**Re: Proposed Spencer Pit  
Part of Lots 14-16, Lots 17 and 18, Concession B, Township of Guelph-Eramosa**

**RE: Hydrogeologic Assessment Peer Review Comments, June 20, 2014  
GM BluePlan on behalf of the Township of Puslinch.**

This letter provides additional information and discussion in response to review comments provided by GM BluePlan Engineering Limited on behalf of the Township of Puslinch in a letter dated June 20, 2014 regarding the proposed Spencer Pit.

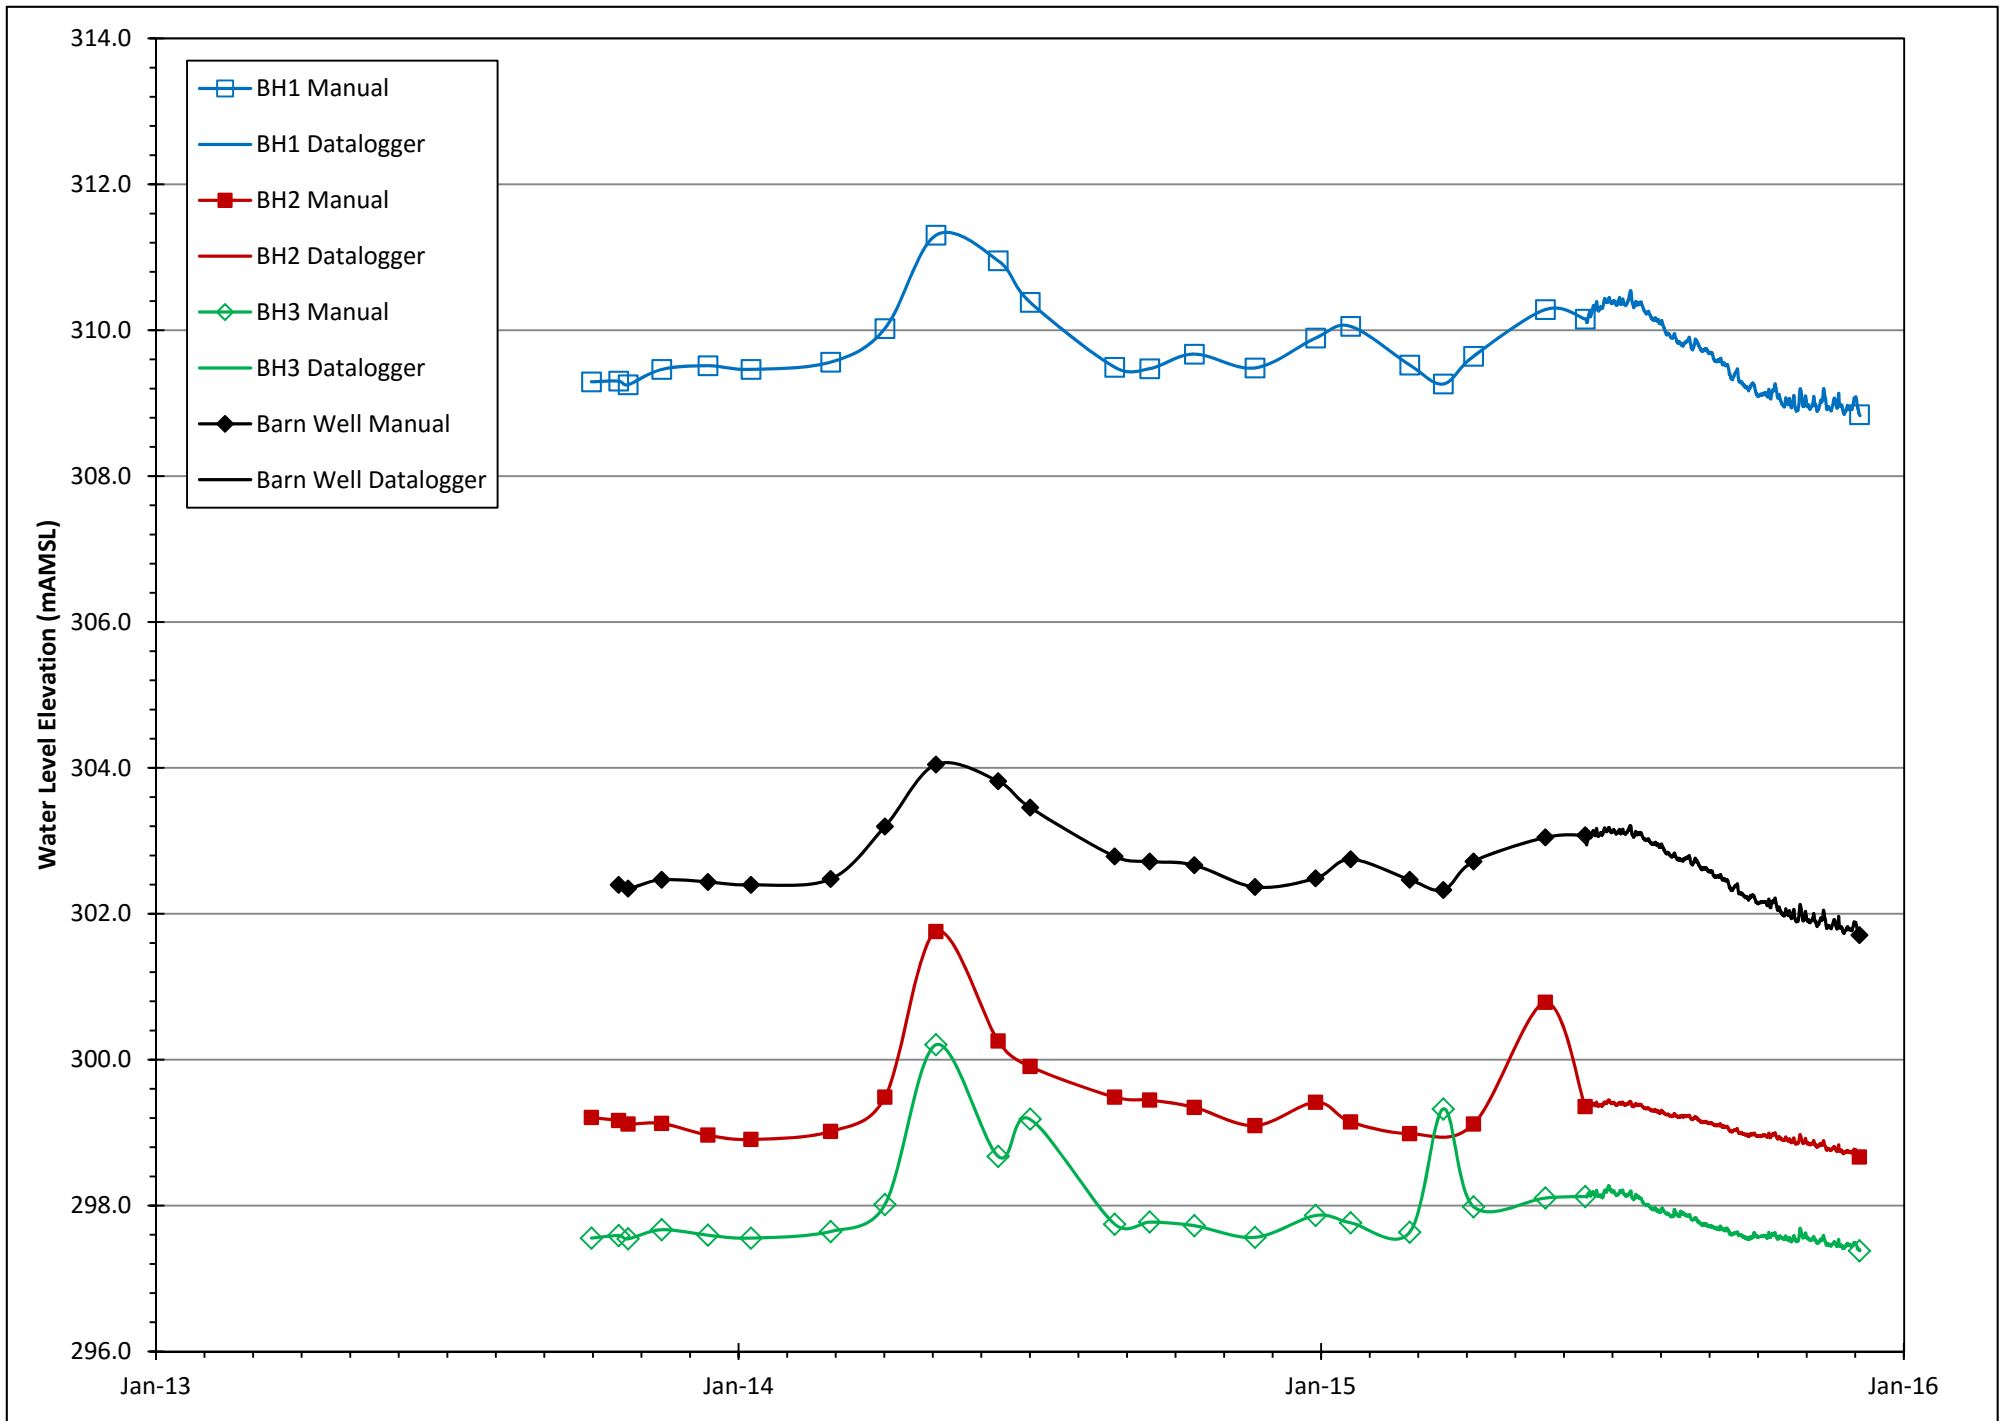
- *To update mitigative measures to include consideration of operations in areas where bedrock exposed through extraction processes.*
- *To update the water level monitoring program to include data collection over the operational period of the pit.*

In addition, groundwater level monitoring has continued at the site. In June 2015 dataloggers were installed at each location and programmed to collect measurements at 4 hour intervals. The updated monitoring results are summarized on the attached table and hydrograph.

In response to comments received by both GRCA and local residents the groundwater monitoring program now includes routine water level measurements, both manually and using dataloggers (already installed), for the life of the pit. Datalogger measurements will be obtained at a 4 hour interval and manual measurements obtained on a quarterly basis. Annual monitoring reports will be provided to MNRF, GRCA and the Township.

### Updated Water Table Contours

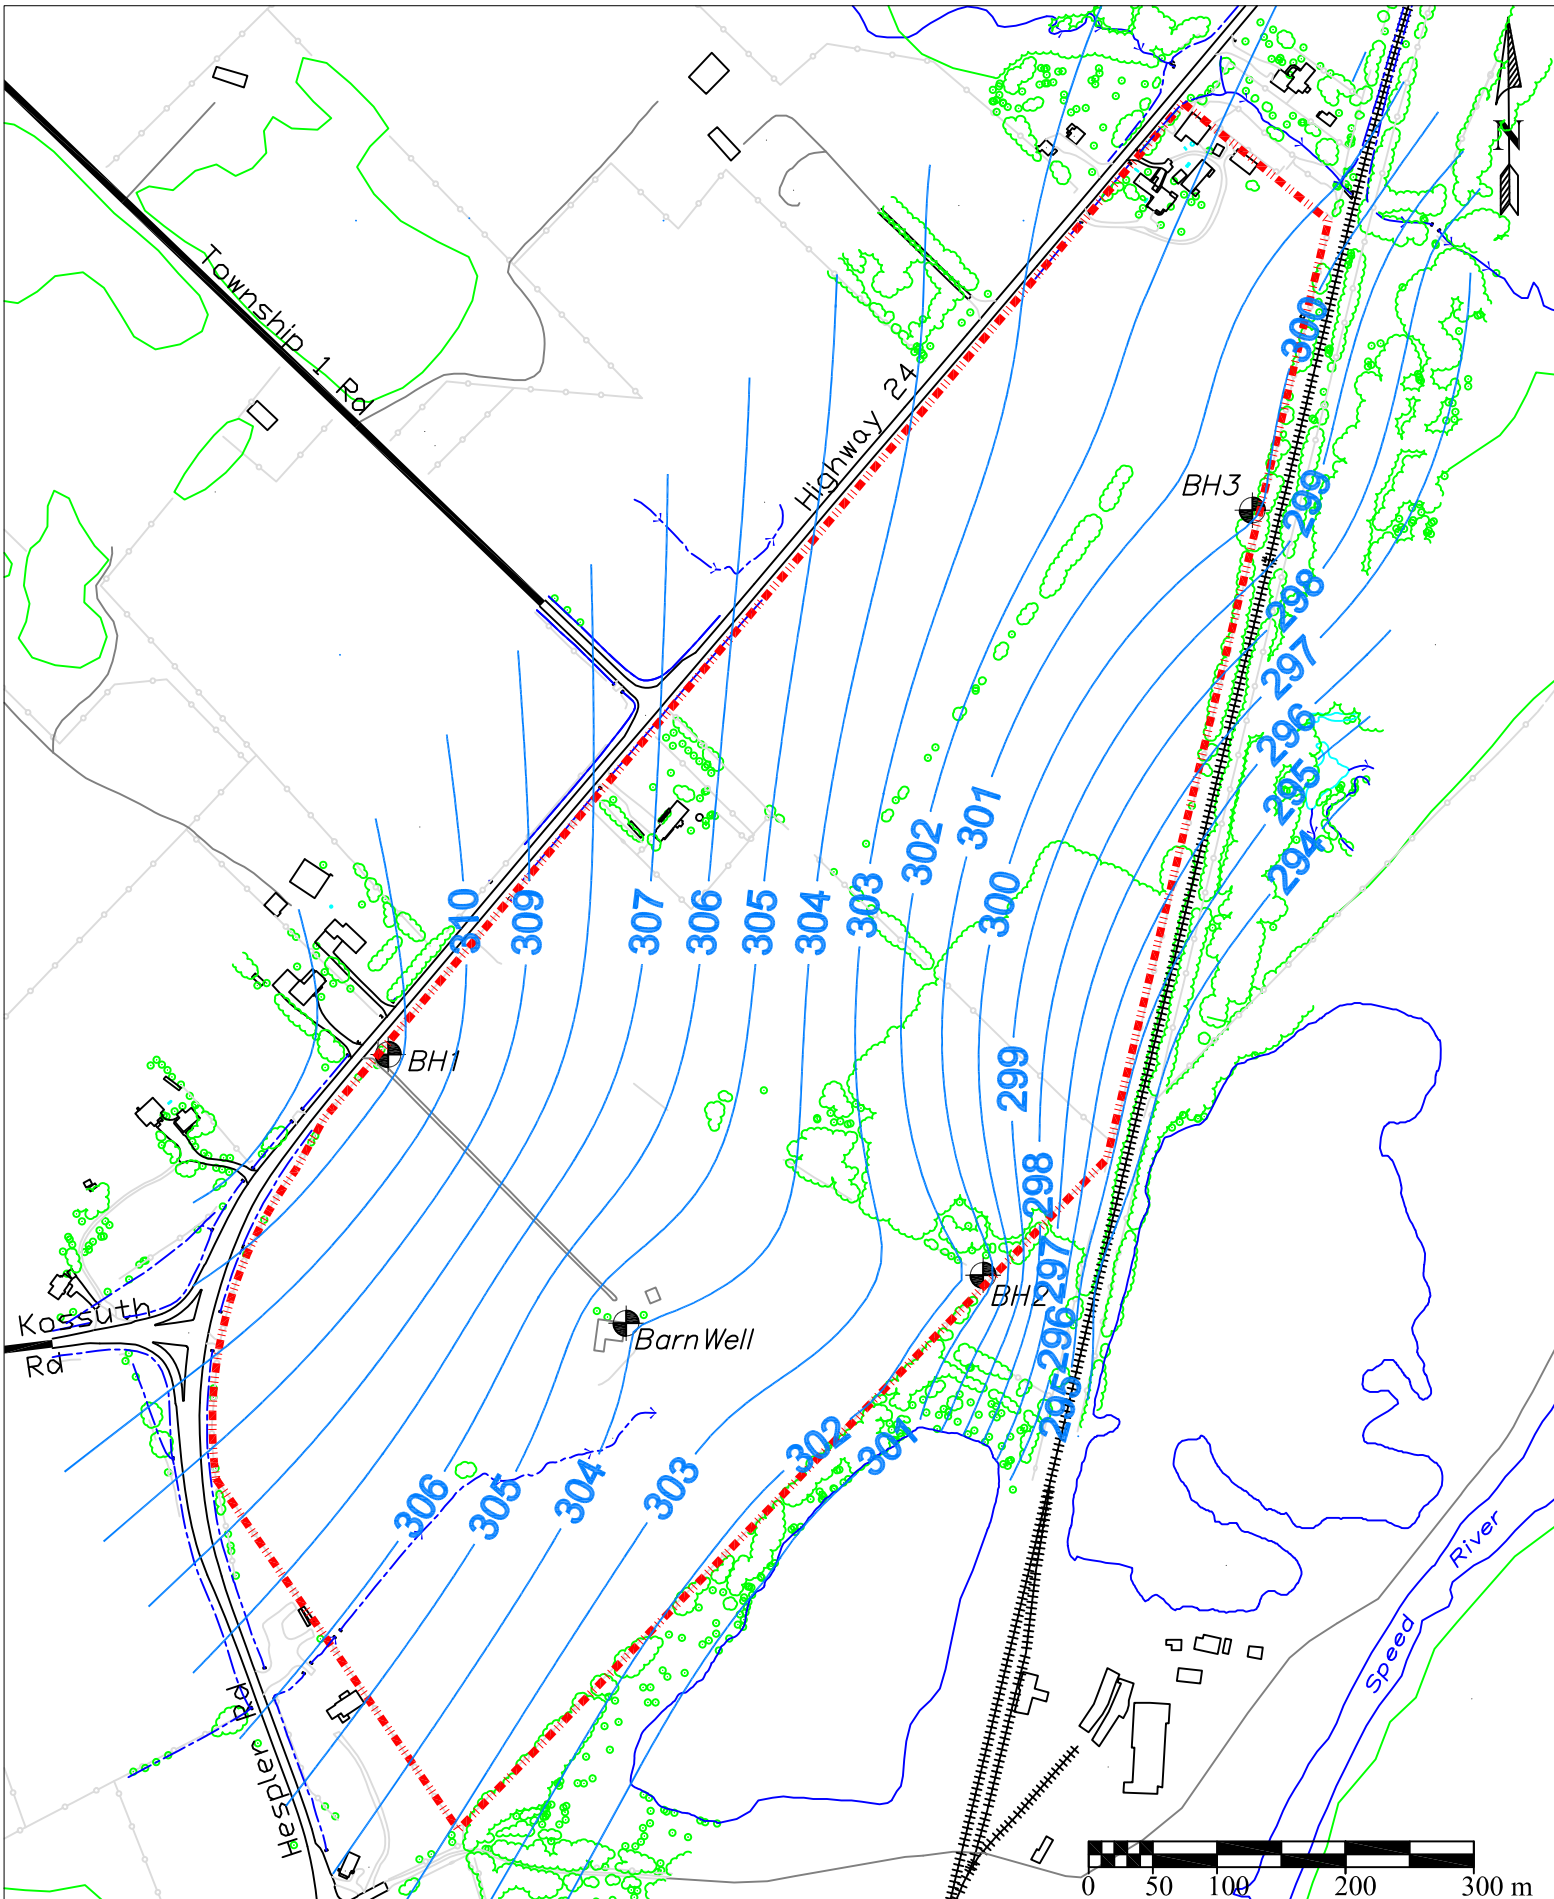
- *Updated contours based on elevations presented for BH3,*
  - *Inclusion of known surface water level elevations and surface water features,*
  - *Presentation of high groundwater elevation data and bedrock surface elevation at each borehole (data point).*

An updated high water table contour map, representative of May 2014 conditions, is also attached for reference. As requested the updated water table map includes surface water elevations for the creek at the railway crossing (301 mASL), wetland within the river valley floor (294.5 mASL), east and west ponds within the Carmeuse Quarry (292 and 301 mASL respectively – see report page 5, last paragraph). We note that surface water elevations at the river east of the quarry ponds will not affect conditions at the site to any significant degree. High water table elevations as compared to bedrock elevations, are provided in the table above. The overall water table pattern is similar to the original interpretation, however the maximum water table elevations are higher based on the continued monitoring and revised reference elevations. Appropriate adjustments to the proposed maximum extraction elevations have been made on the Site Plan.
